NUMBER: 14-002-13 REV. A

GROUP: Fuel System

Fuel Spit Back During Refueling Due To Inlet Check Valve (X48 Lifetime Warranty Extension)

Fig. 1 Fuel Filler Tube

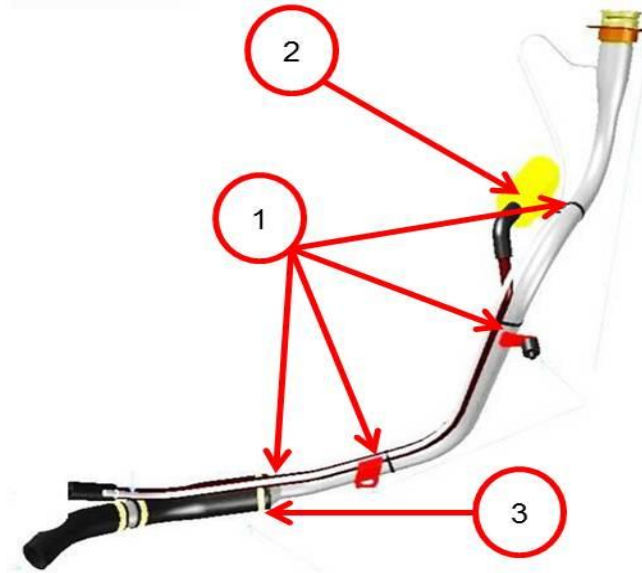
THIS BULLETIN SUPERSEDES SERVICE BULLETIN 14-002-13, DATED JANUARY 30, 2013, WHICH SHOULD BE REMOVED FROM YOUR FILES. ALL REVISIONS ARE HIGHLIGHTED WITH **ASTERISKS**** AND INCLUDE THE ADDITIONAL STEP TO REMOVE AND DISCARD THE EVAPORATIVE FILTER AND TUBE FROM THE FUEL FILLER HOSE.**

1. **The new fuel filler tube (p/n CNNZX390AA) has an evaporative emission hose and filter assembly attached to the filler neck (Fig. 1) that will not be used in this repair. Cut the four tie straps that secure the evaporative filter and hose to the new fuel filler tube. Remove and discard the evaporative filter and hose.**
2. On new fuel filler tube verify and write down existing torque (Fig. 1).

NOTE: It may be necessary to loosen the worm gear hose clamp and rotate to allow the fuel filler neck to fit between the body and frame. If clamp is loosened then once installed re-torque to noted value.
